Z1800-Series

Technical Support Bulletin Manual

Z1800-SERIES TECHNICAL SUPPORT BULLETIN MANUAL

Rear view of programmable power supplies

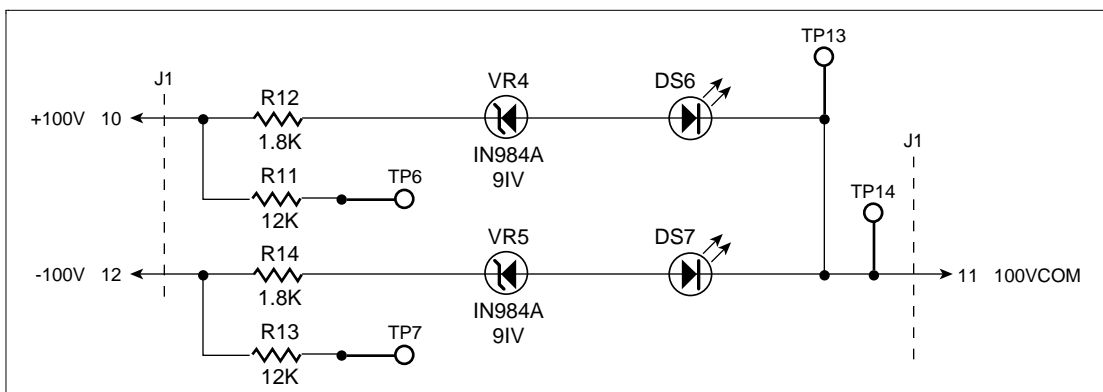
Locate the rear of the power supplies, and determine if the local sense jumpers are connected between terminals + and 2, and terminals 8 and - of both power supplies. Power supply jumpers should be on terminals 3 and 4, and 5 and 6 only. All other jumpers should be removed. (See the illustration below.)

Circuit before change

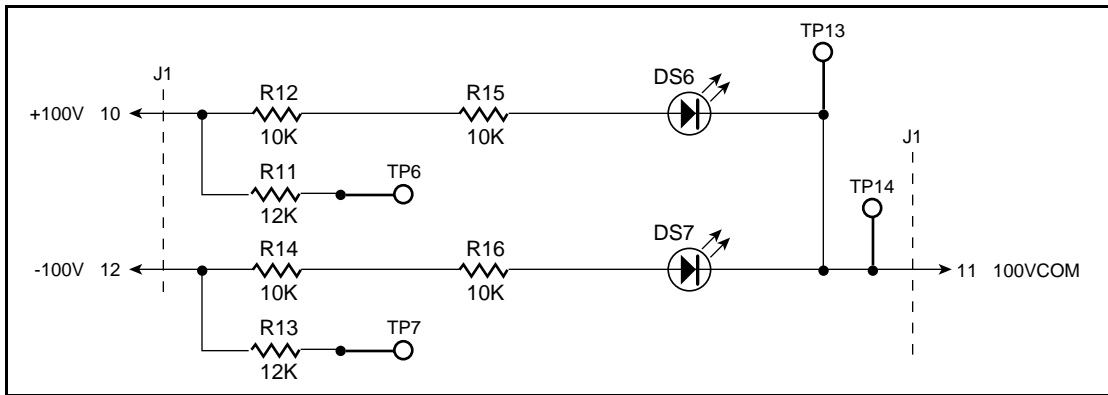
Customers having 1800 models with serial numbers of 102242 and above or 1820 models with serial numbers of 112227 and above have been shipped testers with display panels modified to prevent resistor burn-out. However, if you add the 100 Volt option to one of the earlier Z1800-series systems, you have two options to prevent damage to the display:

- Request a new revision of the board from Teradyne.
 - Modify the board as instructed below.
1. Remove the LED power supply display boards (45034 and 45354 for the Z1800 and 45354 for the Z1820). (See the illustration below.)

2. Remove resistors R12 and R14 and zeners VR4 and VR5.

3. Replace R12 and R14 with 10K-1/2 watt resistors. (See the illustration below.)
4. Replace VR4 and VR5 with 10K-1/2 watt resistors. (See the illustration below.)

Circuit after change

Subject: Ground Wire Addition to Correct Calibration Measurement

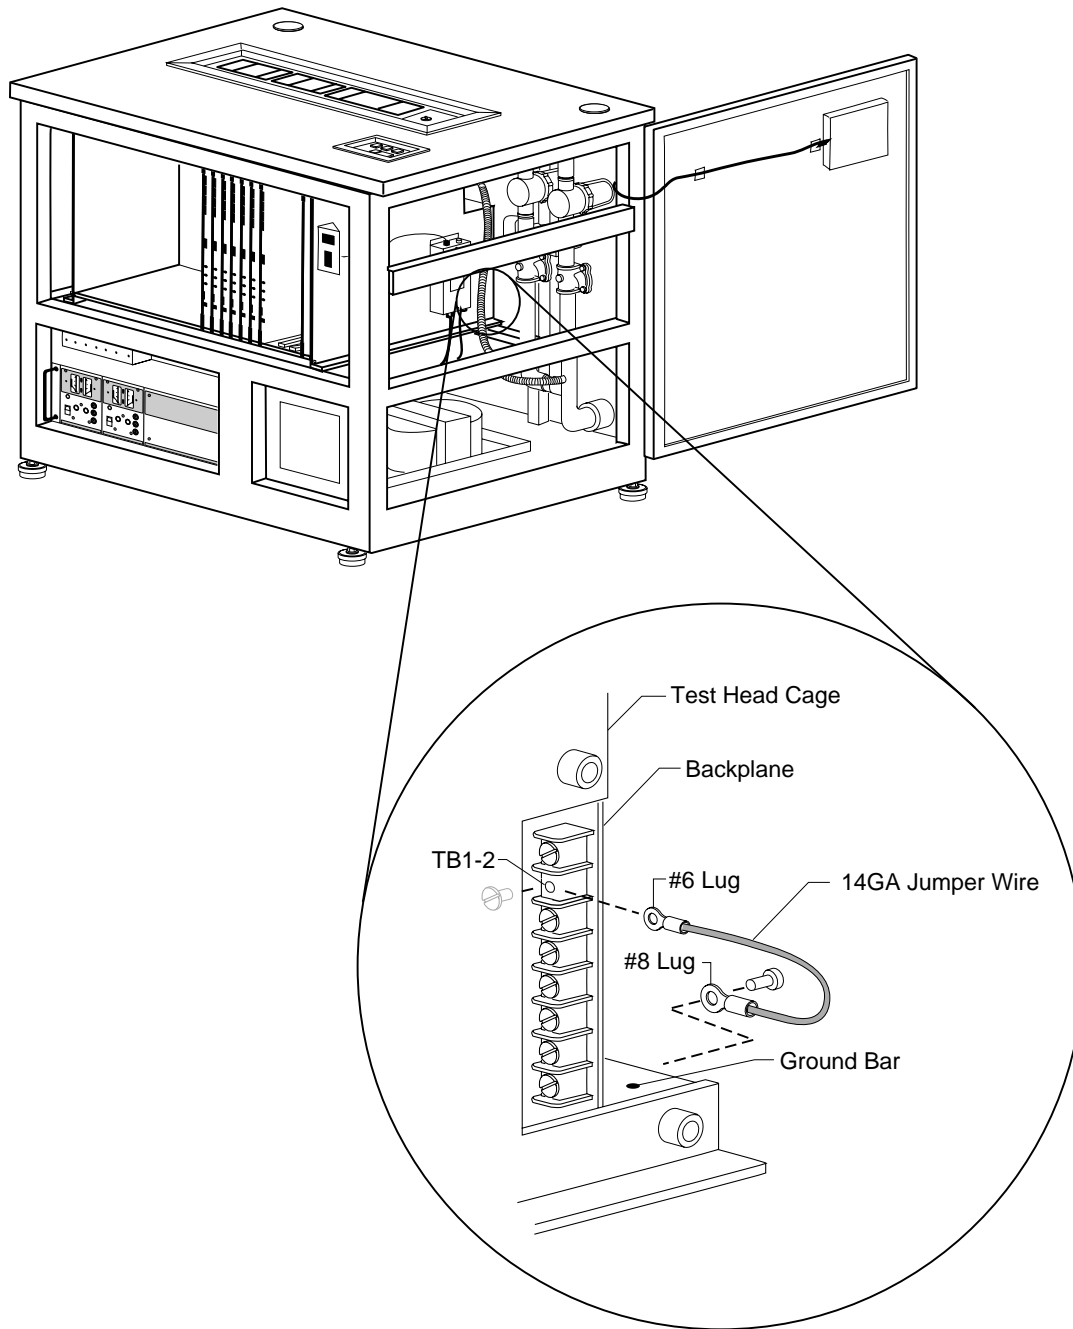
In some Z1800s, THC threshold diagnostic tests will occasionally fail. The failing data is usually out of range by approximately 20mV. The failures are caused by differences in the THC ground and the ATB ground. The grounds are approximately 20mV apart because of excessive resistance between them.

To correct this problem follow the steps listed below, Referring to the illustration on the following page.

1. Shutdown the tester and remove AC power.
2. Unscrew TB1-2 on the backplane. Access to the backplane screws is from the front of the tester.
3. Add the #6 lug terminator to the screw on the backplane, being sure also to reconnect any other wires previously connected to TB1-2. You may need to use a longer screw to accommodate the addition of the ground wire.
4. Insert a 1/4" to 1/2" long #8 screw into the other lug and connect it to any threaded unused hole in the ground bar.

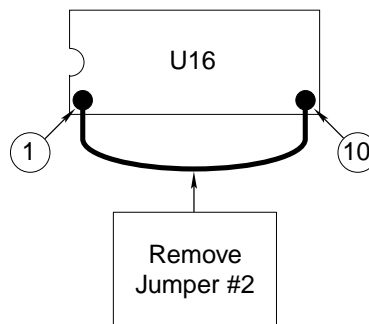
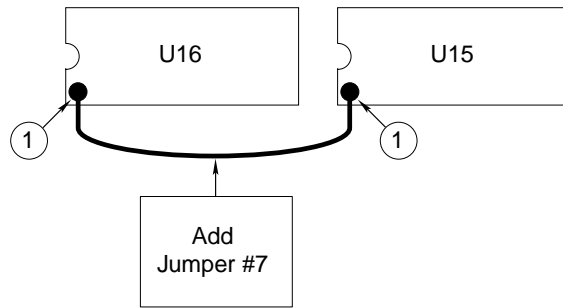
The problem occurs because of erroneous memory transfers due to a jumper connection from U16-1 to U16-10 (GND).

1. Turn off your computer and remove the I/O Adapter board.
2. On the solder side of the board (noncomponent side), remove jumper #2 between U16-1 and U16-10 (GND).

3. Connect U16-1 and U15-1 by soldering a 26-gauge jumper between U16 pin 1 and U15 pin 1.

Corrected Wiring

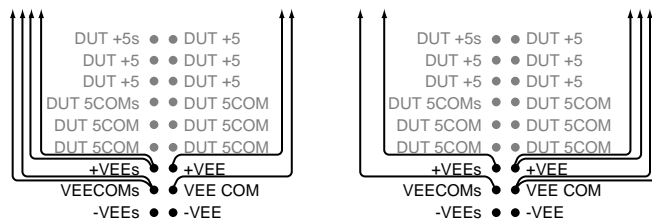
The correct illustration with the Vee power connections swapped is shown below.

In most customer applications and programs this discrepancy does not affect production testing because Vee power connections have one power probe and one sense probe with the same gauge wire. However, if your fixtures were originally wired to make use of heavier gauge wires or probes for power pins, and lighter gauge sense wires, you may wish to correct your fixture wiring by switching the power and sense connections for each of the two power supply outputs.

Figure 2. Jumper Positions on on cabled board (left) and on plug-on board (right)

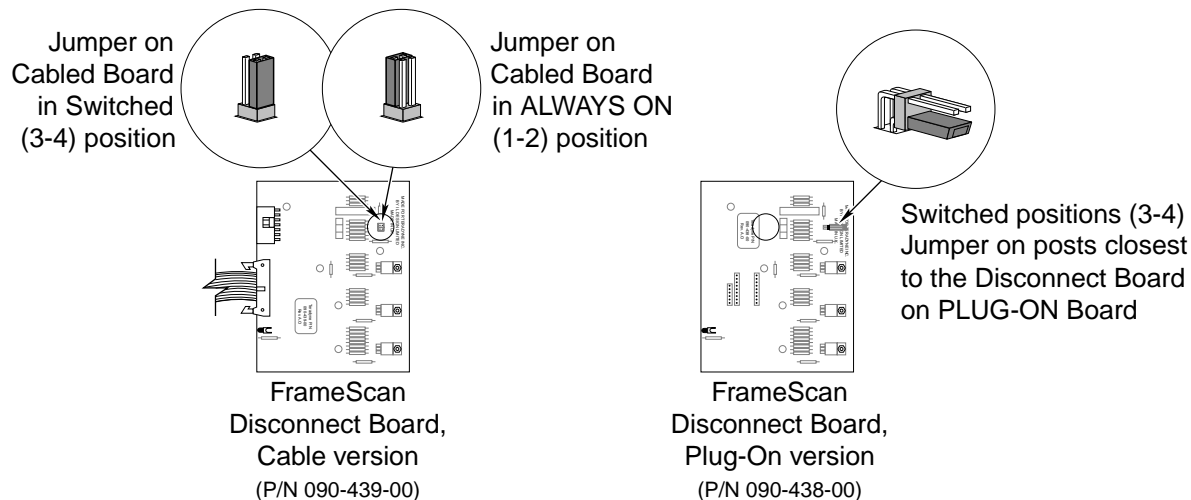
5. Refer to the following figures which show the relative placement of the Enable/Switched Jumper on the FrameScan Disconnect board.

Move the Enable Jumper on the Disconnect board to the EMPTY pair of jumper posts adjacent to its current position. This should install the jumper between posts 3 and 4 and place the board in the Switched Mode of operation. If the jumper is installed between posts 1 and 2, the Disconnect board is always enabled and will not turn off the voltages to the interface.
